Subject: RE: Follow up questions re: corrals in the Village of La Jolla

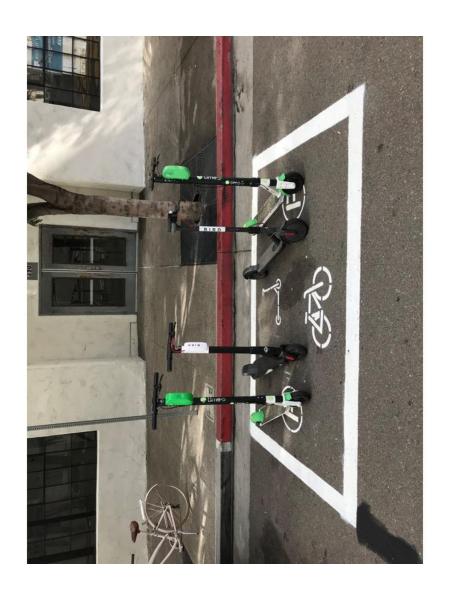
Scooters/Dockless bikes on average are active in D1. The majority are within the areas we shared proposed locations for. The goal is to accommodate this number.
- How was that number arrived at? Vendor provided data.
- 6. Can you send a photo of the proposed Dockless Scooters corral?

8. Is the corral a physical structure or a painted area? What are the dimensions of the corral?

Please see attached. This is a 10x6 space.

Its just paint on the pavement as the photo attached shows. The sizes vary, please see the attached detail.
